DRA75xP, DRA74xP, DRA77xP, DRA76xP SoC for Automotive Infotainment Silicon Revision 1.0

Errata

This document describes the known exceptions to the functional specifications for the device.

Figure 2-1. Simplified SoC 192-MHz Mode DLL Block Diagram

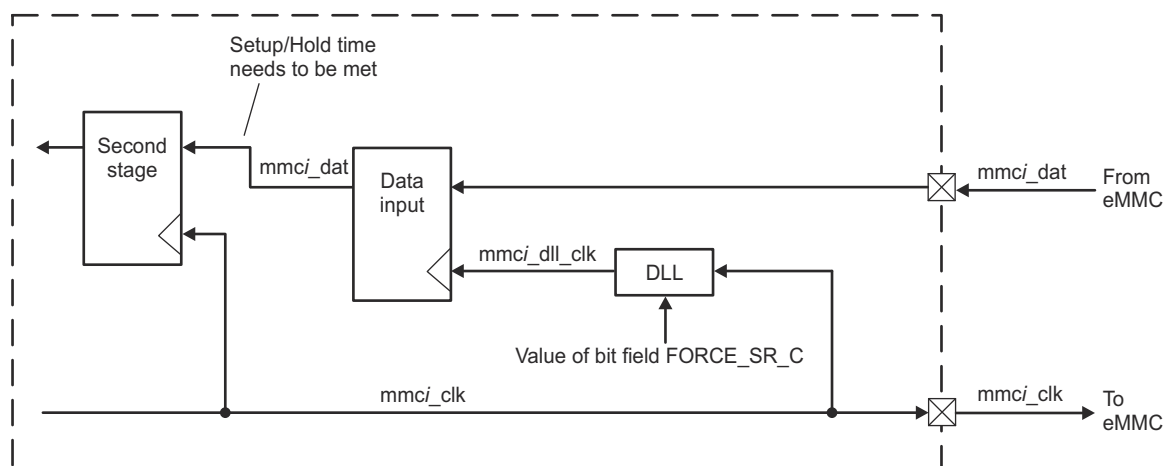
Internal to the MMC module, a second stage latch is used to recapture data captured by DLL delayed clock, `mmci_dll_clk`. The second stage latch captures with the original transmitting clock, `mmci_clk`.

`mmci_dll_clk` and `mmci_clk` both run at the same clock frequency. This results in a narrow range of tuning ratio elements, where the delayed `mmci_dll_clk` comes in phase with `mmci_clk`. If the clocks are in phase, the data captured by the first clock violates the setup and hold time requirements needed for the second stage latch, resulting in incorrectly read data. This is known as tuning re-timing errors.

Figure 4-1. PAB_RevA

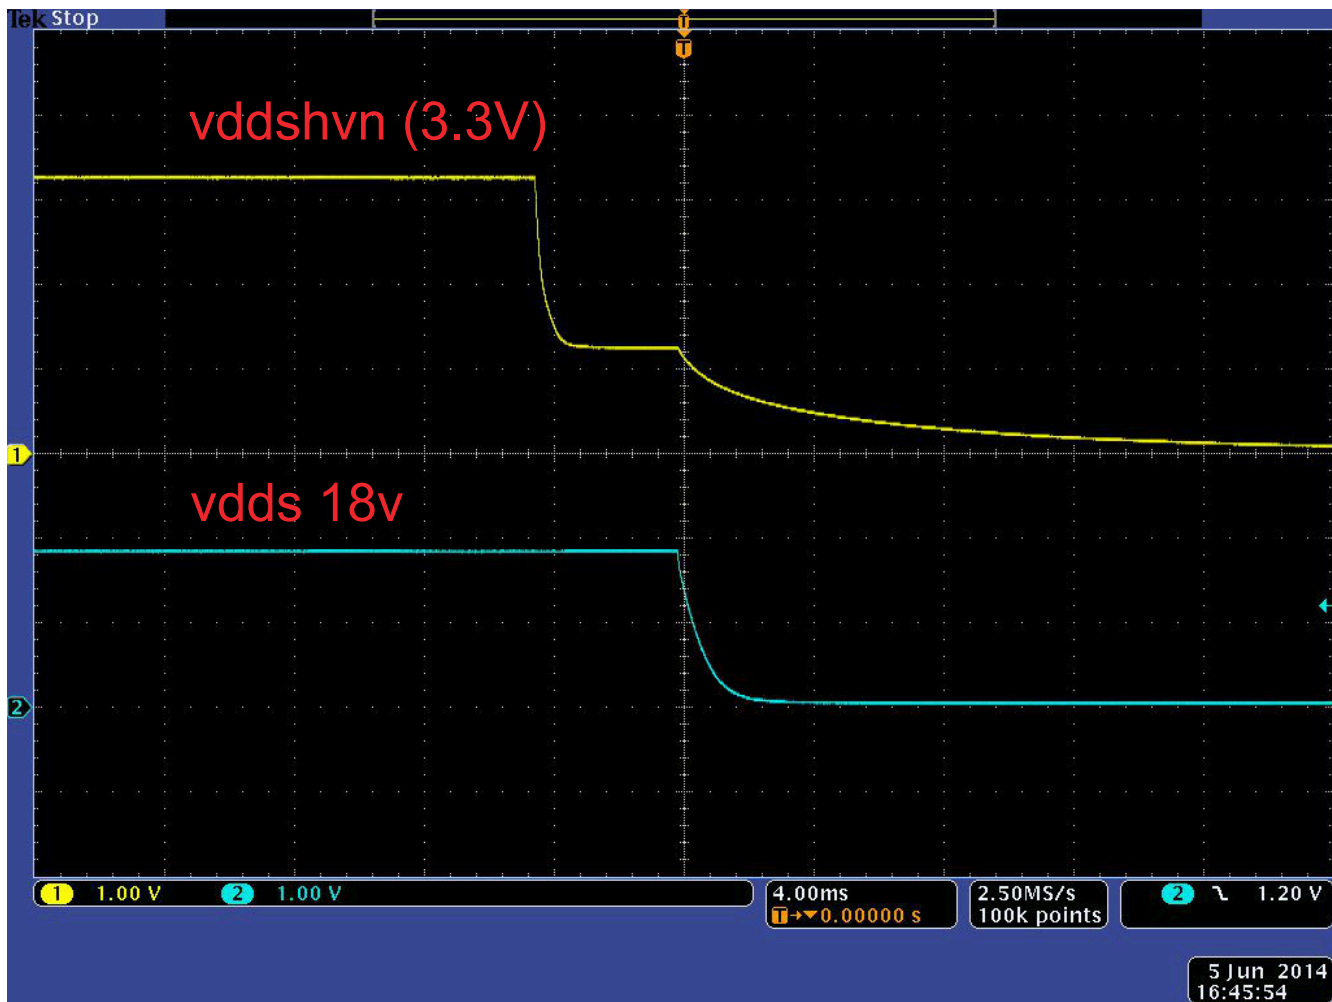
The Data Manual allows the vddshvn rail (in either 3.3V or 1.8V mode) to power down at the same time or before the vdds18v rail. When the vddshvn rail is powered down before the vdds18v rail, the vddshvn rail stays at Plateau Level (<1.5V) until the vdds18v rail is disabled, as shown in the waveform below.

A subset of the SOC's LVCMOS IOs (refer to DM for details) have a pull-up resistor that is active by default, including during reset and power-down. The SOC's IOs that have internal or external pull-ups will stay at Plateau Level (<1.5V) during the power-down. If other ICs on the board that are interfaced to the SOC's LVCMOS signals use a separate supply then it's possible that the other IC's signals can be pulled to the Plateau Level while its power supply is off.

The root cause of the plateau is related to the LVCMOS IO buffer Dual Voltage detection circuitry. The LVCMOS Dual Voltage IO includes voltage comparator circuitry to determine

For systems that use a different 3.3V supply for the SOC and connected ICs, customers should evaluate their system for reliability risk. If necessary, the PMIC OTP power-down sequence can be modified to delay the vddshv[11:1] powerdown to coincide with the vdds18v powerdown. [Note: The 3.3V rail must never be 2.0V above the 1.8V rail.]
